# THE CITY OF DURHAM TRUST

**DM/22/01981/RM Reserved matters application for 470 dwellings  
(appearance, landscaping, layout and scale) pursuant to DM/20/03558/OUT,  
land to the east of Regents Court, Sherburn Road, Durham City**

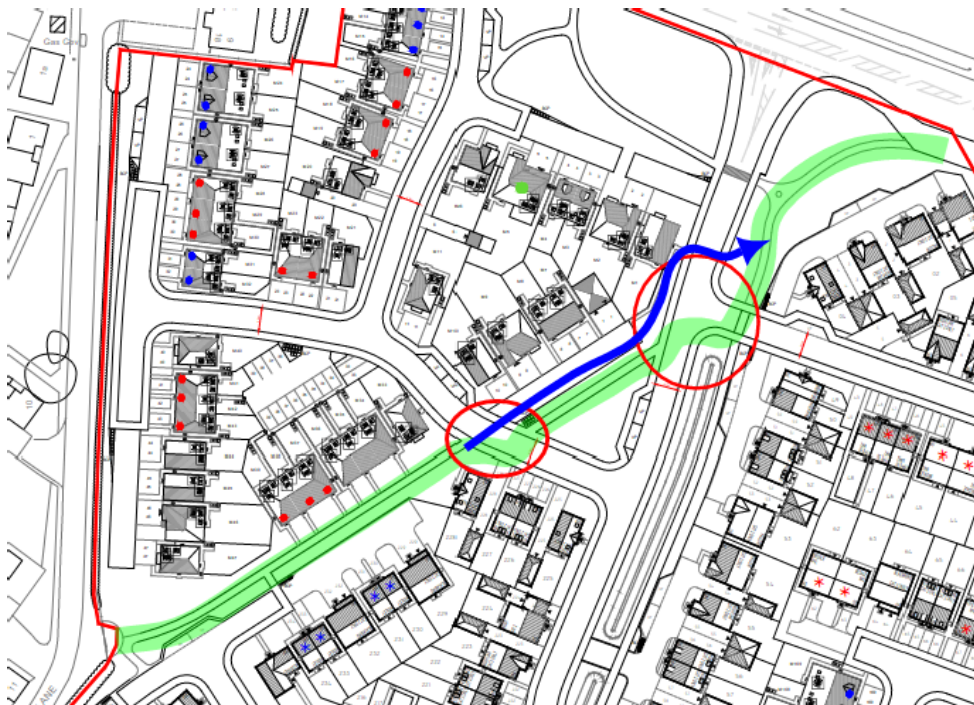
The Trust welcomes the addition, in the November 2022 revision, of a footpath connection to the pedestrian crossing point at Damson Way, but objects to the design which, like the other external path connections, fails the test of directness and legibility. The route is shown in yellow on the excerpt below. An additional footpath/cycleway connection to the A181 further east, from the access road which terminates on the northern site boundary, would beneficially reduce active travel distances from the whole of the eastern part of the site to Damson Way. The Trust would like to see this provided.

Such a connection would, for example, reduce the overall walking/cycling distance to the nearest secondary school. Possible routes are shown in green in the above excerpt. The Trust favours aligning the connection with the access road, making the most direct link to the main highway. This will be more obvious and legible to anyone passing the mouth of the access road as well as emerging opposite the west-bound bus stop lay-by.

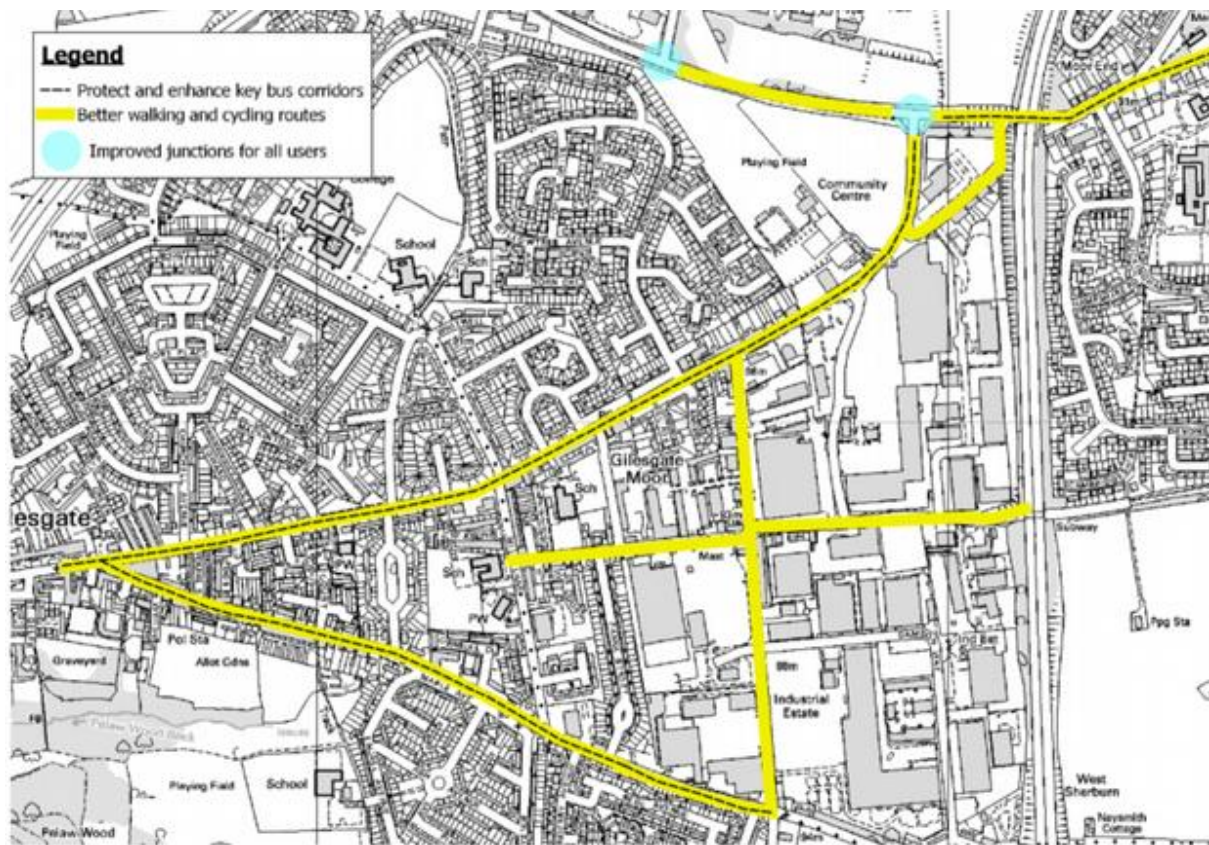
The Trust was critical of the approved Masterplan with its lack of clarity regarding which internal paths and external connections would be suitable for cycling. It appears from the submitted plans that the Reserved Matters application has provided no cycle paths within the site. The outline application envisaged a cycle route linking Bent House Lane and Damson Way, potentially rerouting the National Cycle Network Route 14. Here below are the remains of that proposal, highlighted in green on an extract of the submitted site plan.

The alignment of the western part of the route has been improved in the revision, but in contrast with the approved 'Masterplan' the rest of the route is still illegible, disjointed, and clearly no wider than the 1.8m footways. It does not appear to be intended as a cycle route,

The junctions circled in red above need to be redesigned to give pedestrians and cyclists safe and direct access to the next section of the route. The blue line shows how this might be achieved, by adopting the access to some of the houses as a pedestrian and cycle way, and realigning the route to cross the main access road at right angles to improve safety. Introducing a bend in the access road would allow the pedestrian/cycle route to be straightened further, and reduce motor vehicle speeds at the crossing.

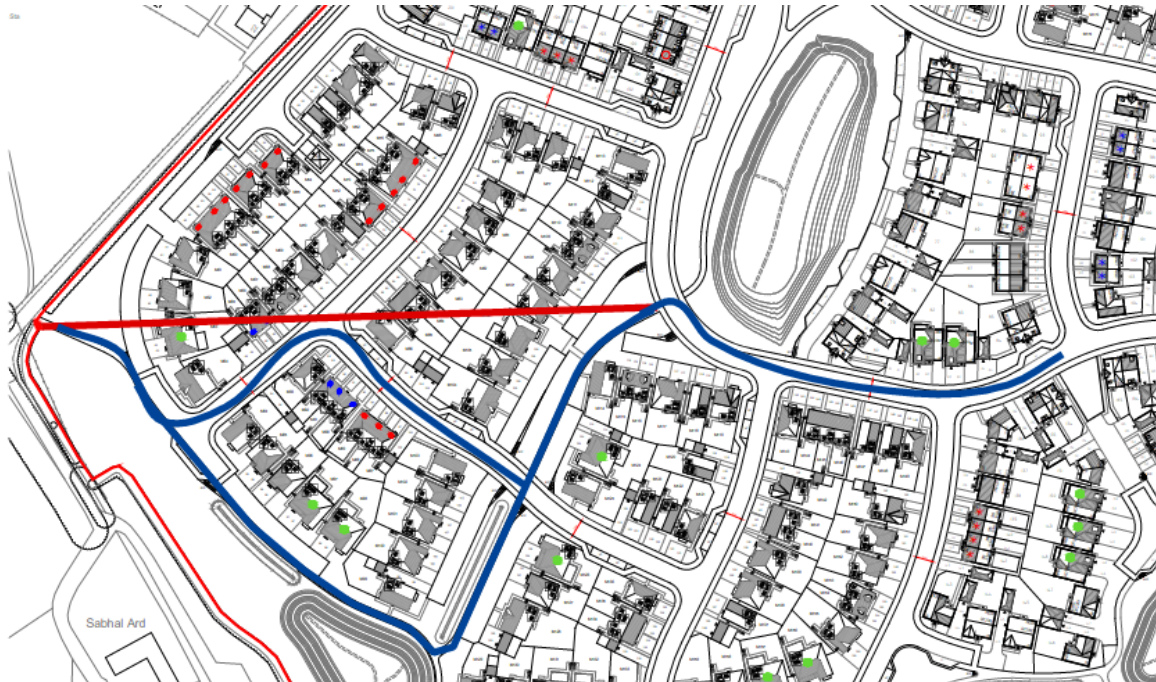
Much has been covered under Policy 5 above, but it is worth noting Policy 21(a) which prioritises walking, cycling and public transport, and Policy 21(b) requiring *“appropriate, well designed, permeable and direct routes for walking, cycling and bus access, so that new developments clearly link to existing services and facilities”*. The overall layout of the development does not provide the most direct routes for walkers and cyclists to access the surrounding amenities. Access from the southern part of the site to the SW for travel into

Durham city centre via Old Durham and the riverbanks could be made more direct by realigning the road layout. Compare the proposed alignments in blue with the direct route in red in the excerpt below. The layout was primarily designed around the vehicular access. Cycling access appears to be entirely via the road network.

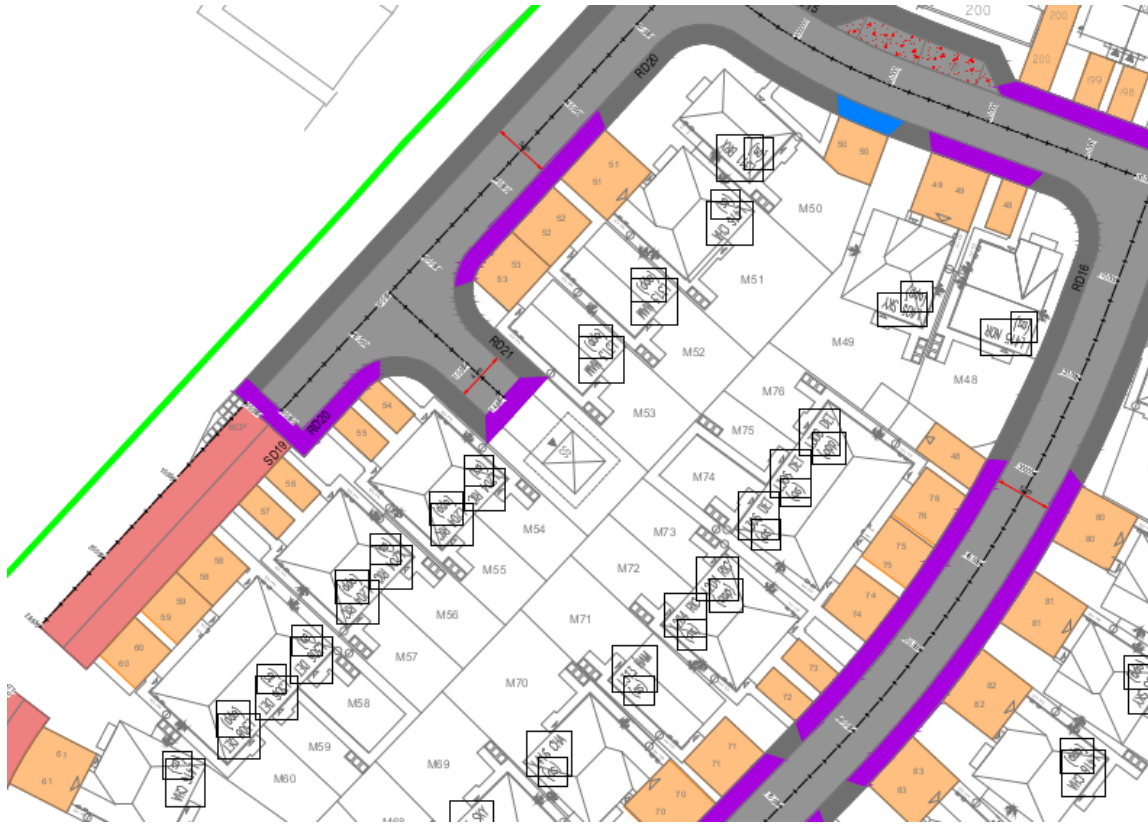
The layout does not promote pedestrian access to Damson Way or Dragon Lane: the alignment of pedestrian routes has been dictated by the main vehicular access. The applicant offers nothing on promoting public transport in section 3, beyond noting the site's location. The layout does not promote pedestrian access to Damson Way or Dragon Lane: the alignment of pedestrian routes has been dictated by the main vehicular access. The applicant offers nothing on promoting public transport in section 3, beyond noting the site's location. The response to section 4 on housing needs simply states what the applicant proposes to build and provides no assessment or evidence on the local needs. Regarding well-defined streets and spaces (section 7) the applicant asserts that buildings turn corners well, but in fact the layout is remarkably rigid and rectilinear (see below), and inferior to the indicative layouts in the approved masterplan.
